# AGENDA CITY OF CEDAR FALLS, IOWA PLANNING AND ZONING COMMISSION MEETING WEDNESDAY, OCTOBER 28, 2020 5:30 PM AT CITY HALL VIA VIDEO CONFERENCE

SUBJECT: Tidal Wave Site Plan: Case # SP20-010

REQUEST: Site plan approval for construction of a new car wash.

SITE LAYOUT AND **DIMENSION PLAN**

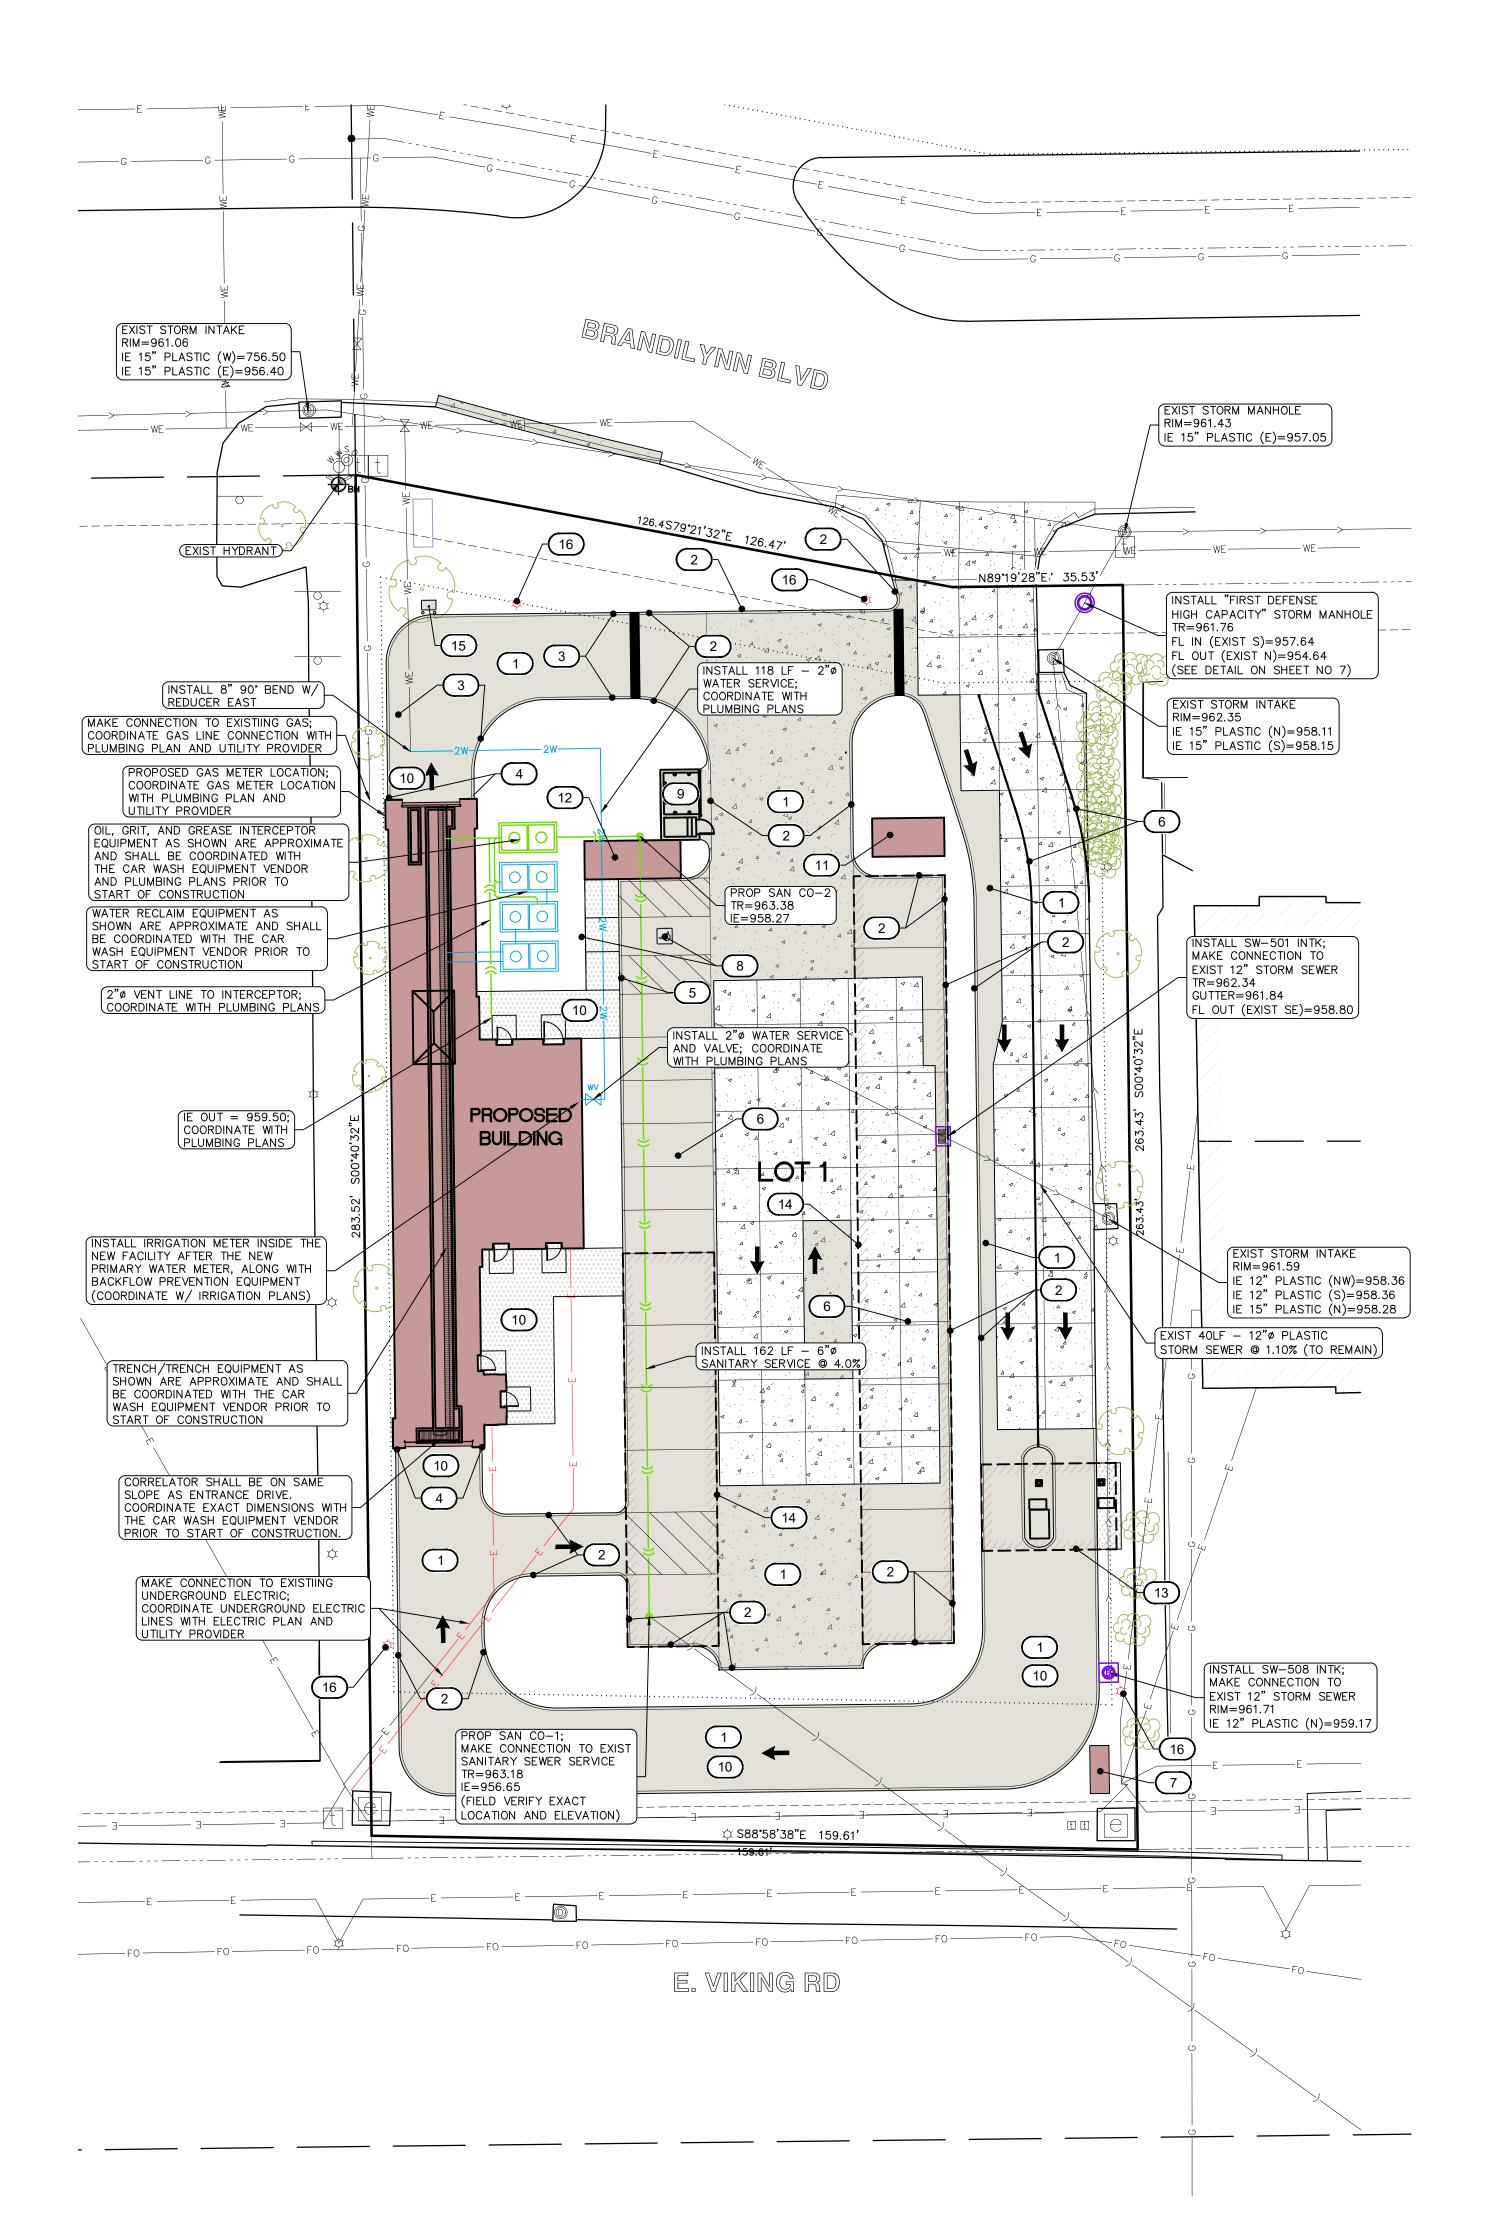
An updated plan set illustrating the required 20-foot perimeter setback area and associated adjustments to the landscaping plan is required.

Introduction of this site plan is for discussion and public comment. An updated plan set illustrating the 20-foot perimeter setback area and signage details and a formal recommendation will be brought forward at the next meeting.

LANDSCAPE PLAN

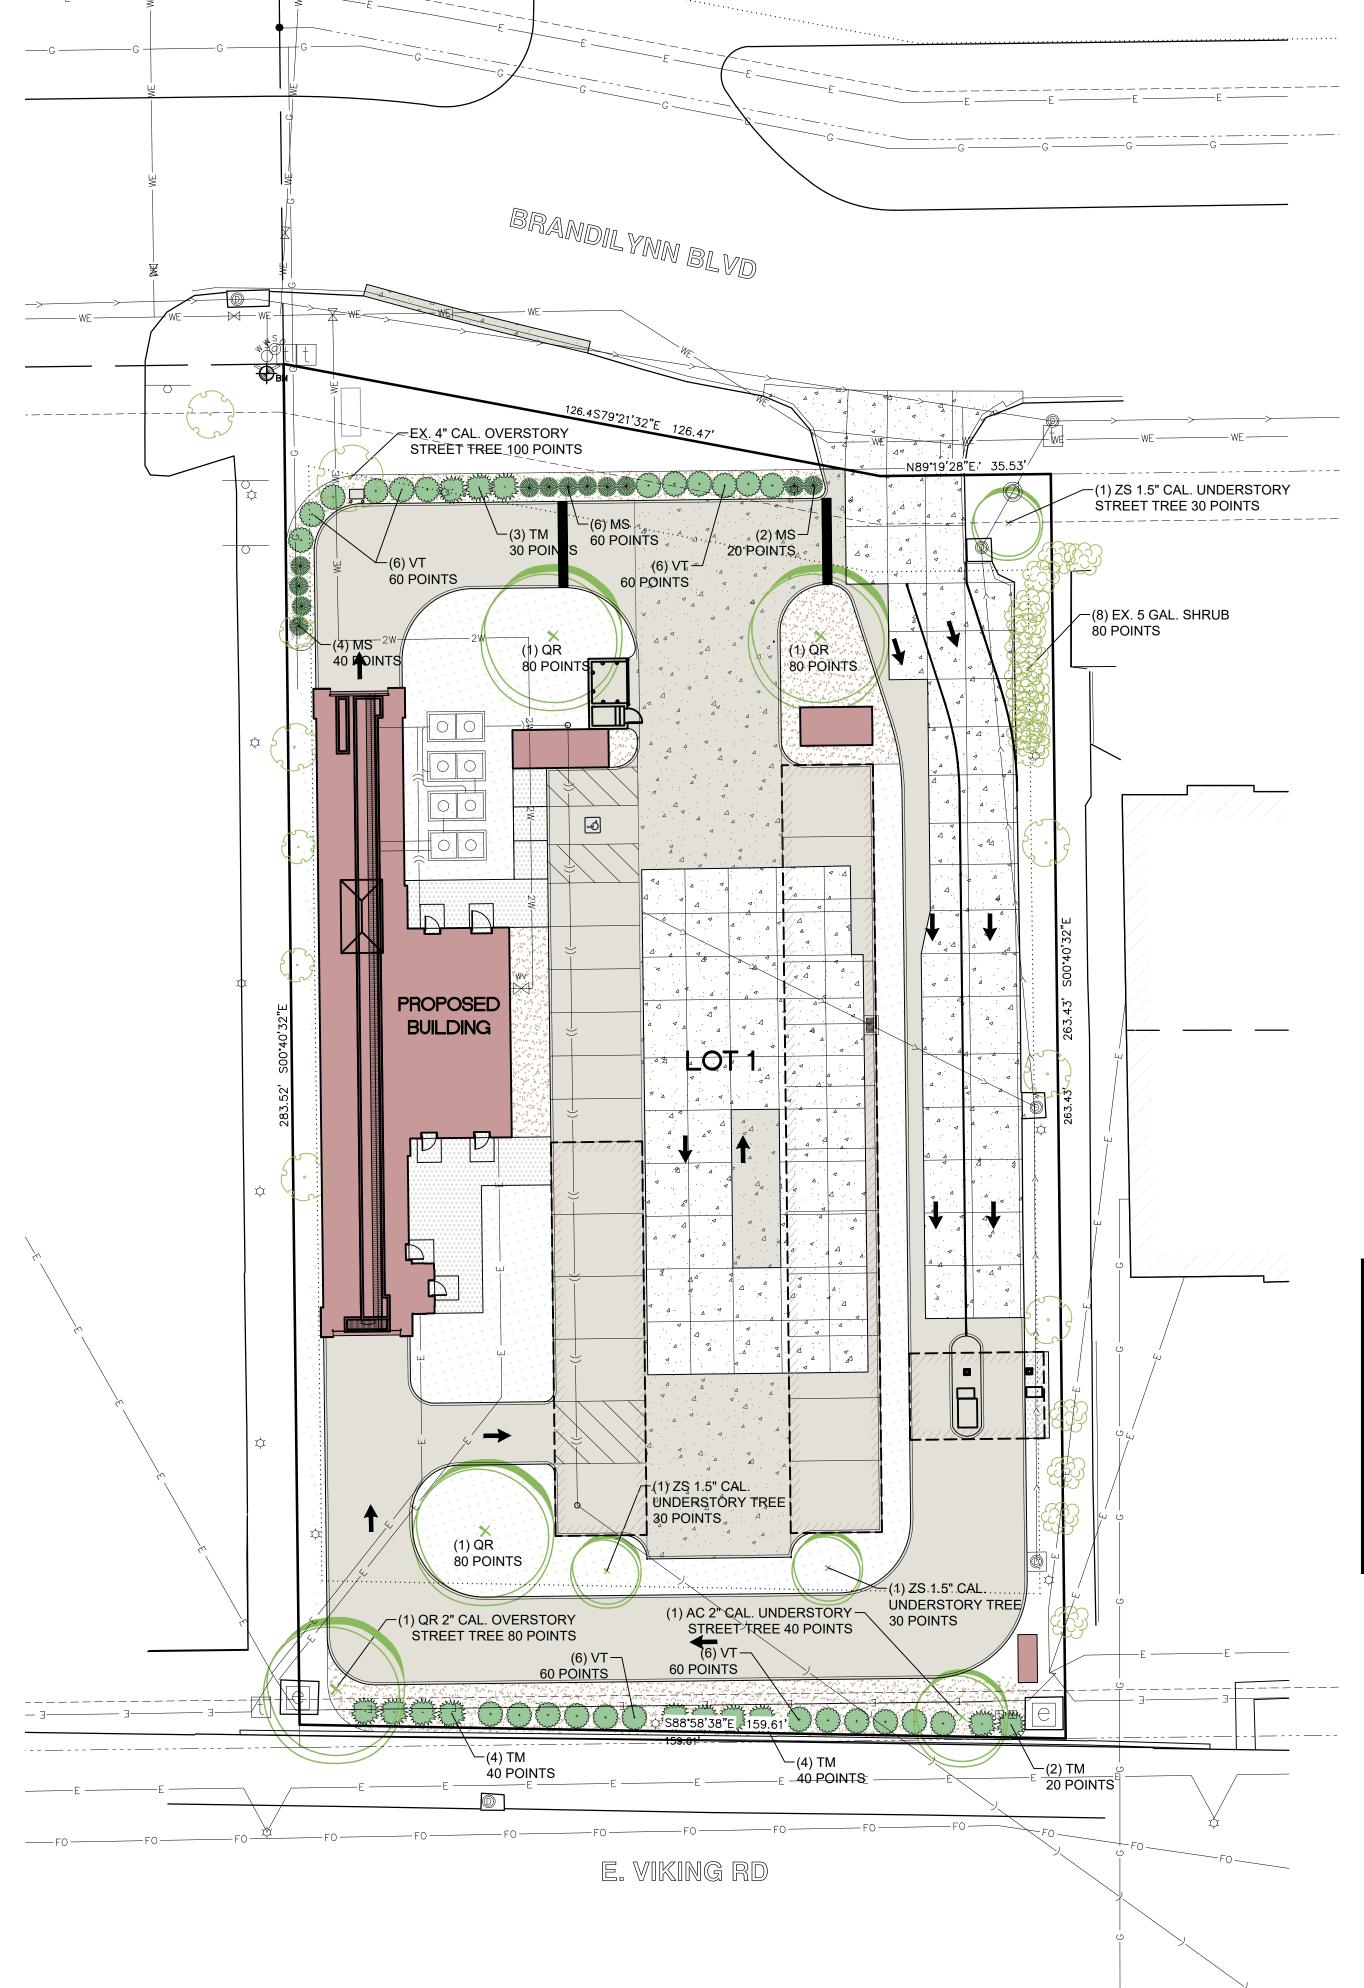
5) <u>Landscaping:</u> The HWY-1 District requires landscaping at the rate of 0.02 points per sq. ft. of total development site area which comes to 864 points required. Their plan achieves 870 points. An additional 241 points are required for street tree planting and their plan achieves 250.

In addition to parking lot trees, there are trees located along the street frontages, with shrubs and additional trees being located around each of the buildings as required. The required screening around the parking/vehicular use area is also fulfilled by their proposed plan. **Landscaping requirements are met.**
